STAFF REPORT
KETCHUM PLANNING AND ZONING COMMISSION
MEETING OF AUGUST 11, 2020

PROJECT: 4th & Walnut Ave Commercial Development Design Review

FILE NUMBER: P20-046

APPLICATION TYPE: Design Review

Design Review August 11th 2020 AF-101

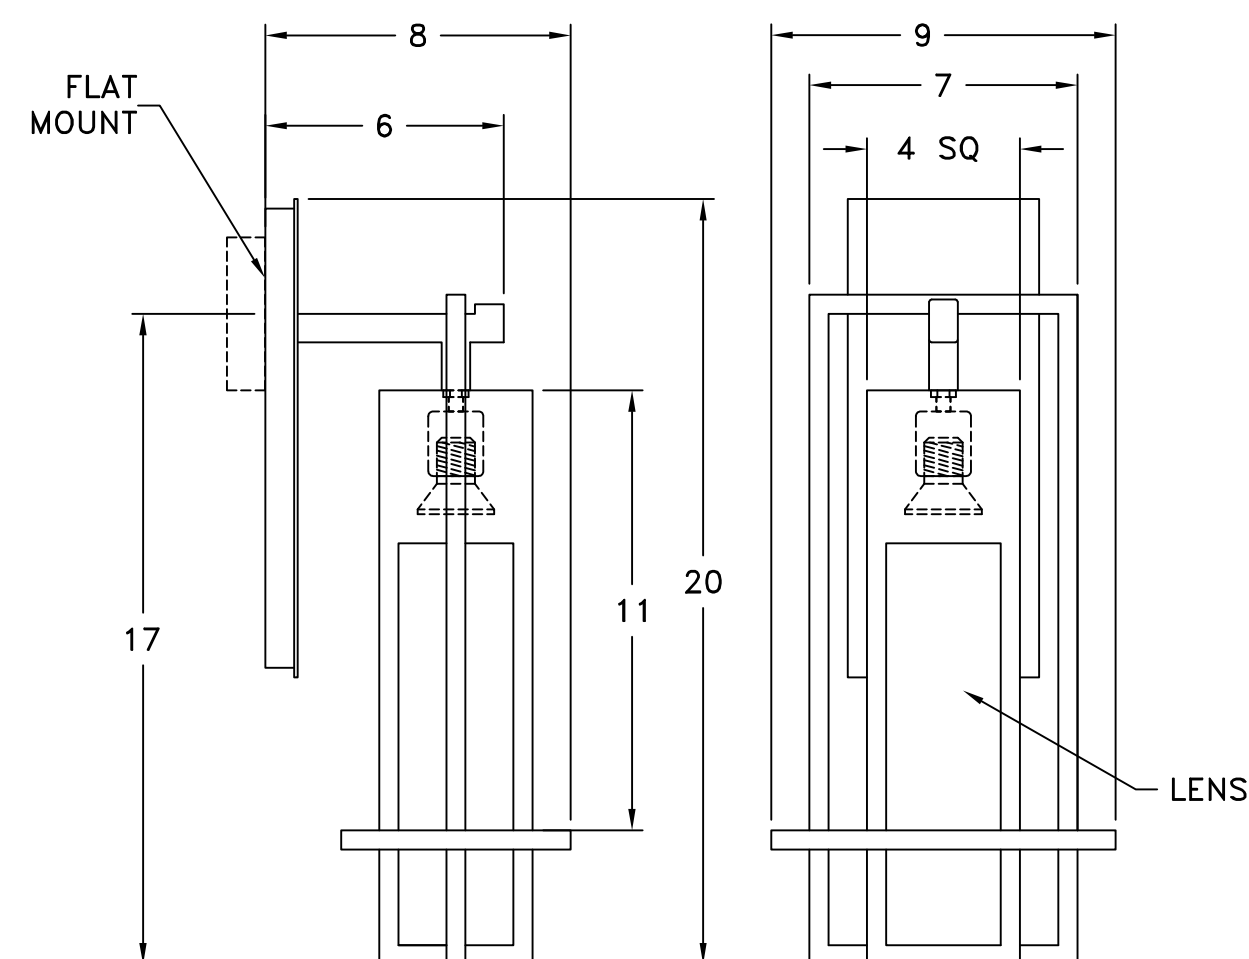
Figure 2: Exterior Materials, Project Plans, Sheet AF-101

1 TYPE A
SCALE: 1" = 1'-0"

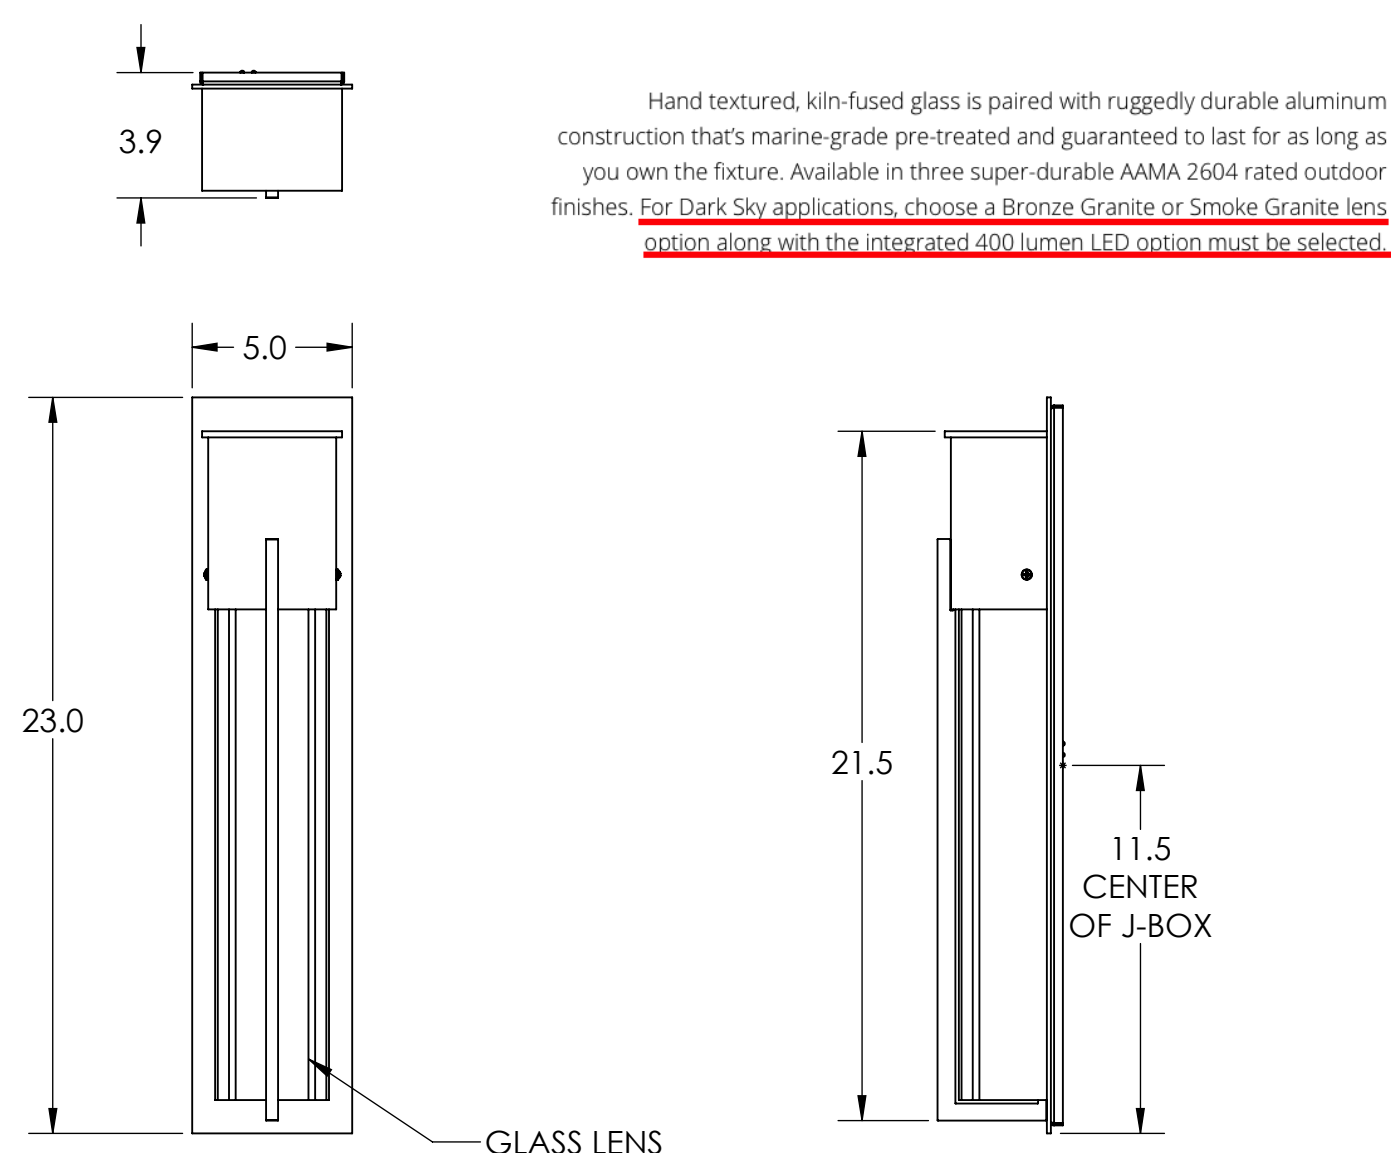
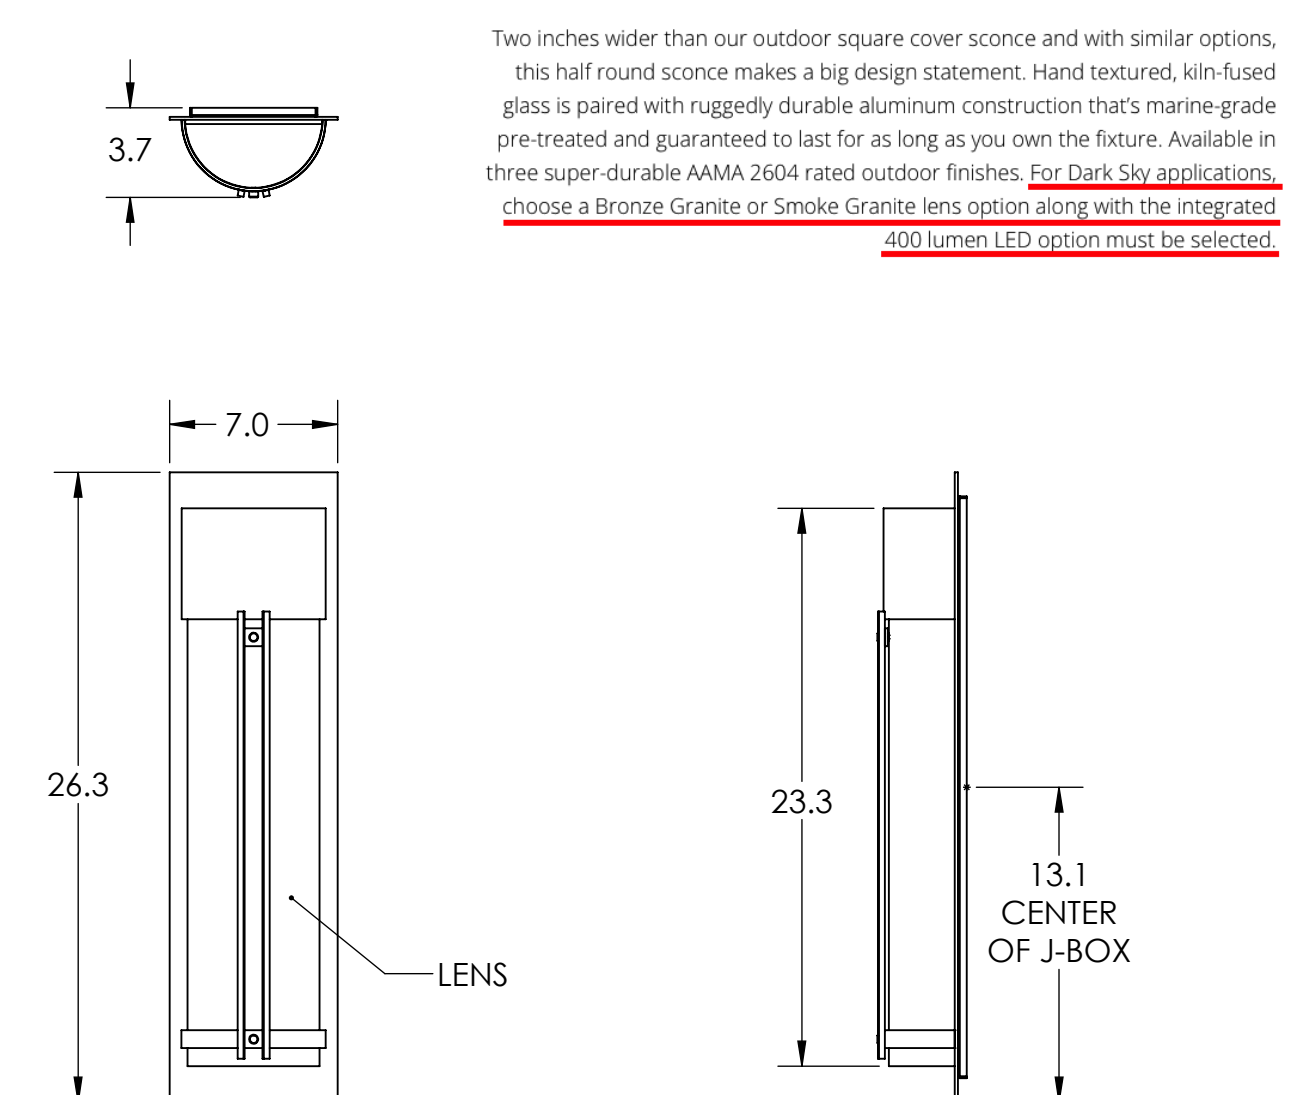
The applicant has provided specifications for the proposed exterior lighting fixtures on Sheet AF-102 of the updated project plans. The lighting plan proposes four types of fixtures—three fully shielded wall sconces and one recessed can light. The first and second floor plans (Sheets A-101 & A-102) show the proposed locations of the four types of fixtures. The wall sconces frame the entrances to the retail spaces and the coffee shop. The lighting enhances safety for pedestrians entering and exiting the mixed-use building. The proposed exterior lighting is Dark Sky compliant as the fixtures shield the light bulbs to minimize glare and light trespass (KMC 17.132.030.H).
